Technical Service Bulletin

94 Daytime running light (DRL) inoperative (DTC 02895 or 02897)

94 15 68 2032184/5 June 29, 2015. Supersedes Technical Service Bulletin Group 94 number 14-43 dated June 9, 2014 for reasons listed below.

Model(s)	Year	VIN Range	Vehicle-Specific Equipment
Q5	2013 - 2015	All	Not applicable

Figure 3. Current (left) and early (right) style LED DRL units.

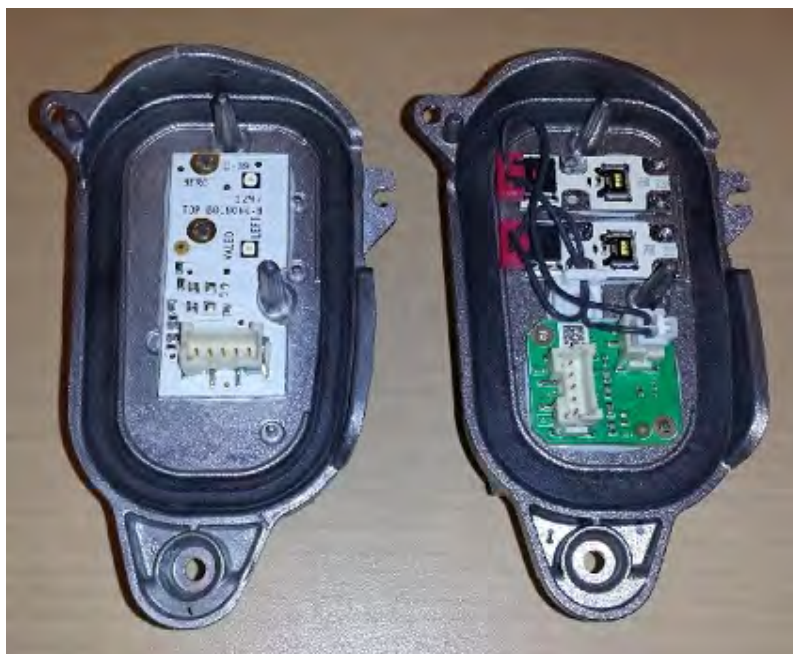
As of March 12th, 2013 production, the LED unit with heat sink has been updated (Figure 3). If a failure occurs, these parts do *not* need to be replaced in pairs.

6. The appearance of the replacement part for the LED DRL has changed, but functionality is the same. If an LED DRL needs to be replaced, they do not need to be replaced as a pair.
